# REVIEW OF APPLICATION FOR CERTIFICATION BY THE LOW IMPACT HYDROPOWER INSTITUTE OF THE CHICOPEE VALLEY AQUEDUCT FISH HATCHERY HYDROELECTRIC FACILITY

Prepared by Patricia McIlvaine

December 20, 2016

Figure 3 Site Plan

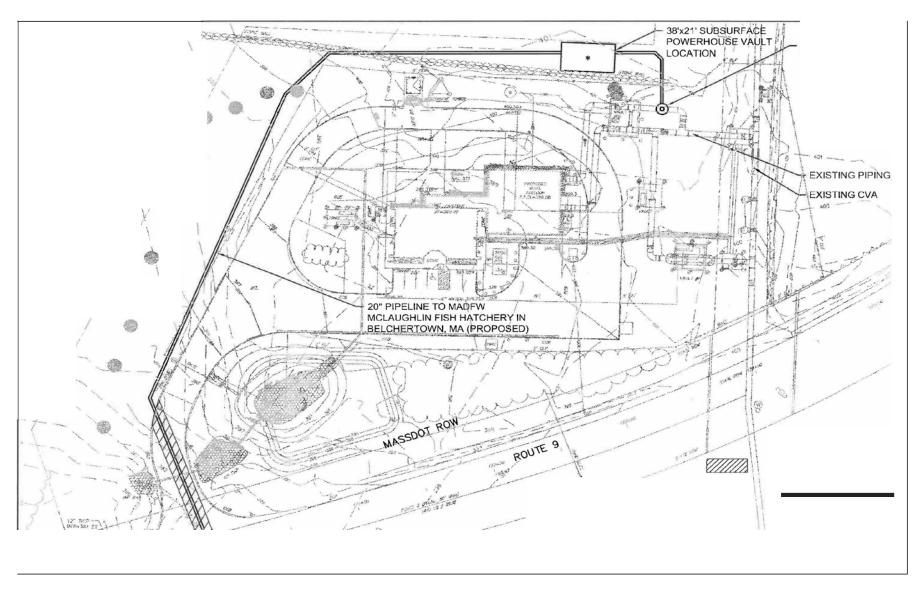
The project pipeline travels through undeveloped land. The Ware Disinfection Facility is a 2.96-acre site. The site plan on Figure 3 in Appendix A illustrates the location of the powerhouse on the WDF site.

The conduit hydropower project will be located on the grounds of an existing water treatment plant. The powerhouse will be constructed in an already disturbed and cleared area. The site consists of a treatment plant building, bituminous concrete pavement encircling the building, with a number of vaults for metering, treatment, flow control, and testing. The CVA itself has an associated clear right-of-way. There are no land at the CVA Fish Hatchery Project that has significant ecological value for protecting water quality, aesthetics, or low-impact recreation, and there has been no Shoreline Management Plan (SMP) or similar protection required at the facility.
